PLANNING & DEVELOPMENT COMMITTEE

2 DECEMBER 2025

2.2 Development Application DA 312/2025(1) - 2 Kalkadoon Place 9

2.3 Development Application DA 761/2024(1) - 25 Lone Pine Avenue 61

Figure 13: City's markup depicting the solar array area to be removed from the northern boundary (red hatch)

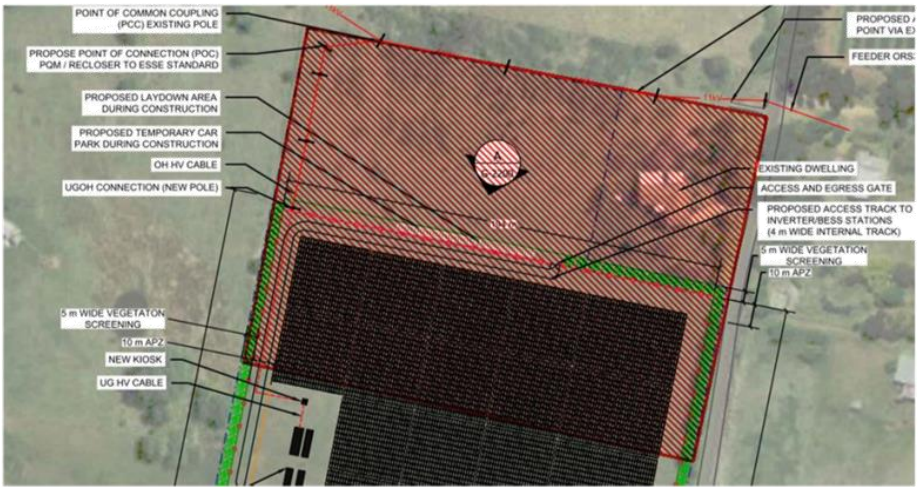
28. On 21 May 2025, Council Officers recommended further amendments be made to reduce the layout in line with the base of the dam on the adjoining western boundary (Figure 13). Noting a greater reduction in the extent of solar panels was not adopted.

Figure 19 - Plant community types on adjacent land

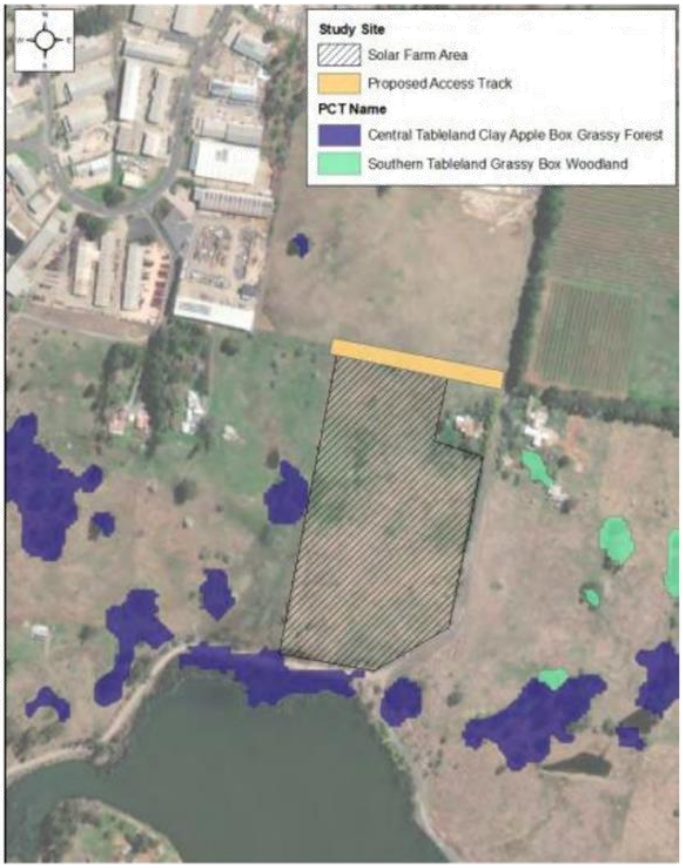
97. Stands of Central Tableland Clay Apple Box Grassy Forest (PCT 3366) exist on the western and southern boundary of the subject site (Figure 19).

Figure 21 – Receptor observation points

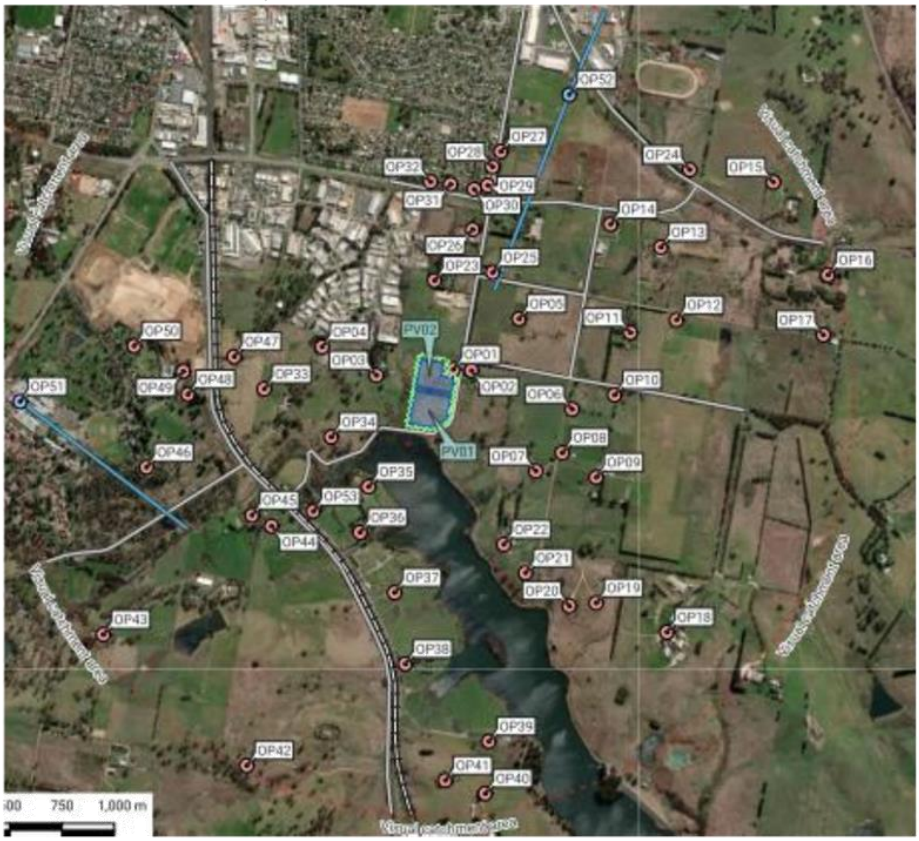
109. The Glint and Glare Study nominate receptor points around the subject site at properties, and on roadways as OP or RT (Figure 21). The study indicates that without mitigation, residents driving on Lone Pine Avenue (RT07) would be exposed to glint and glare for a period that exceeds the maximum acceptable level prescribed under the Large-Scale Solar Energy Guideline.

110. Residents at Bloomfield House (OP03) will be exposed to moderate glare impact requiring mitigation measures to reduce impacts as far as practicable. However, the Glint and Glare Study claim the proposed perimeter vegetation screening is deemed adequate with no additional mitigation measures proposed (key receptor points are summarised below).

Figure 2 - approved subdivision plan under DA 233/2015(1)

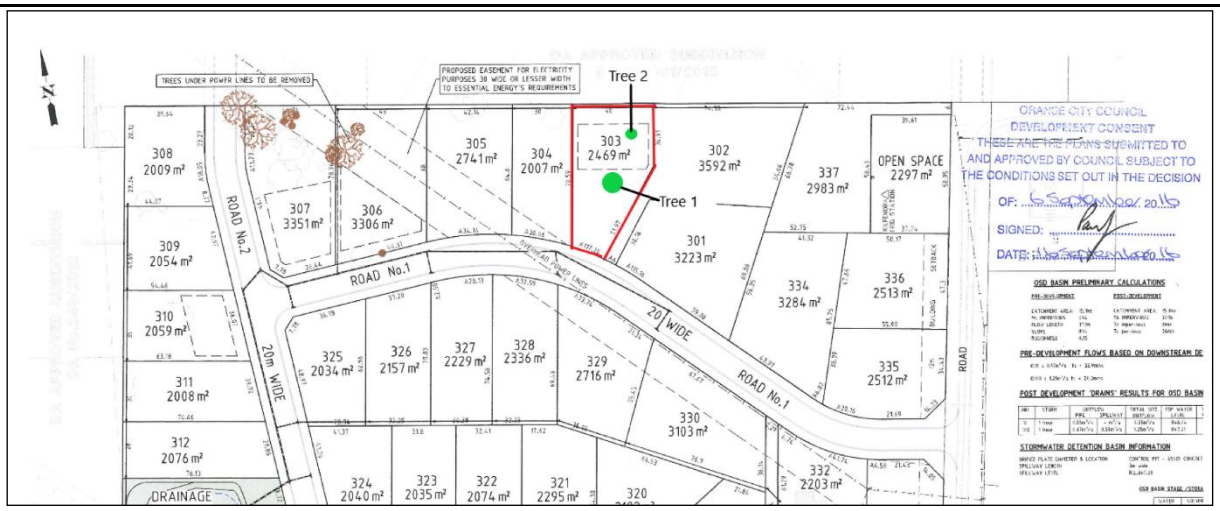
The modified development seeks to remove a Eucalyptus gonio calyx tree and amend the building envelope established for the lot during the original subdivision (refer to Figure 2). The site was identified as Lot 303 in the originally approved stamped plans.

Figure 3 - proposed site plan with amended building envelope

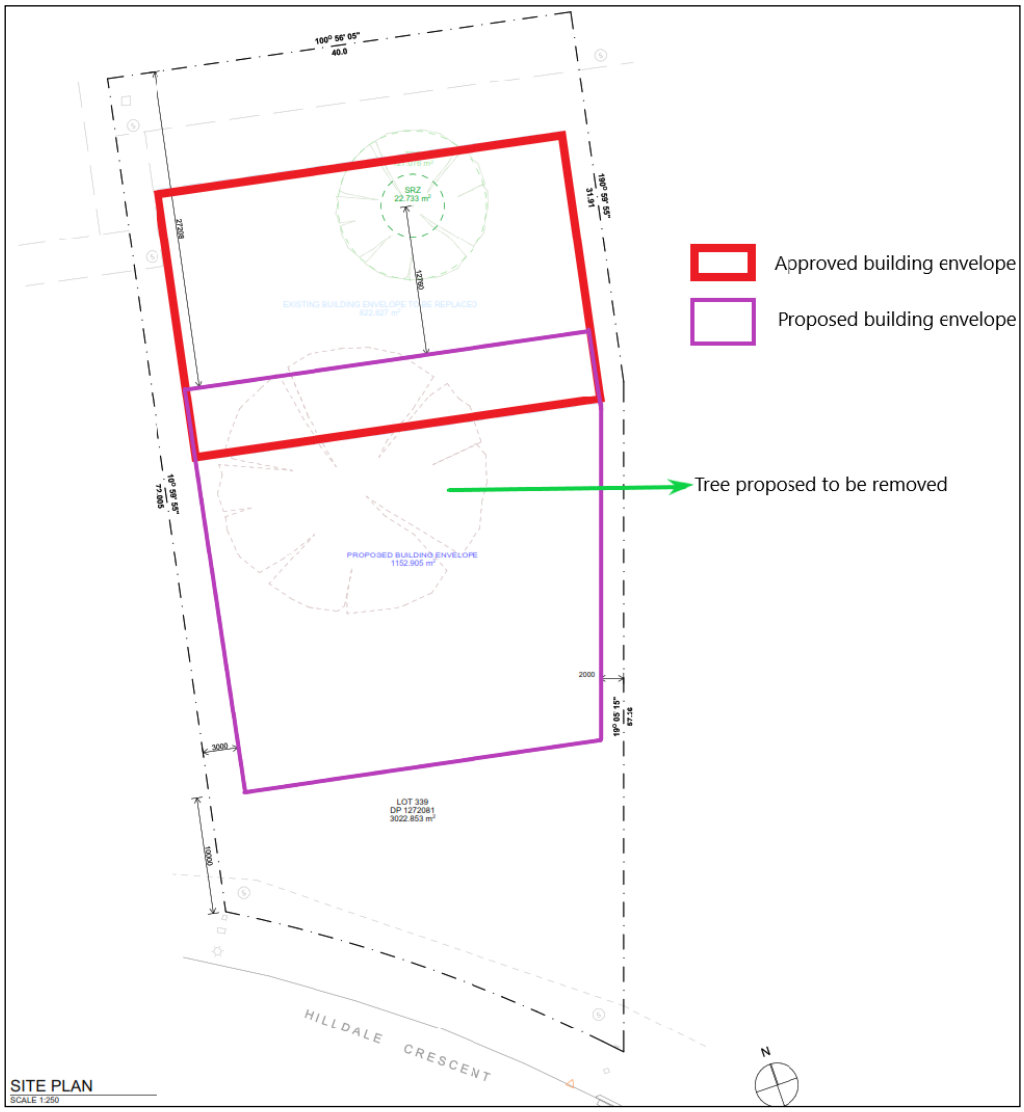
The modified building envelope proposed as part of this application is shown in Figure 3. An Arborist Report has been submitted in support of the application, however, the report is considered insufficient in addressing the health and structural integrity of the tree. It primarily focuses on supporting the construction of a future dwelling rather than providing an objective assessment of the tree's condition.
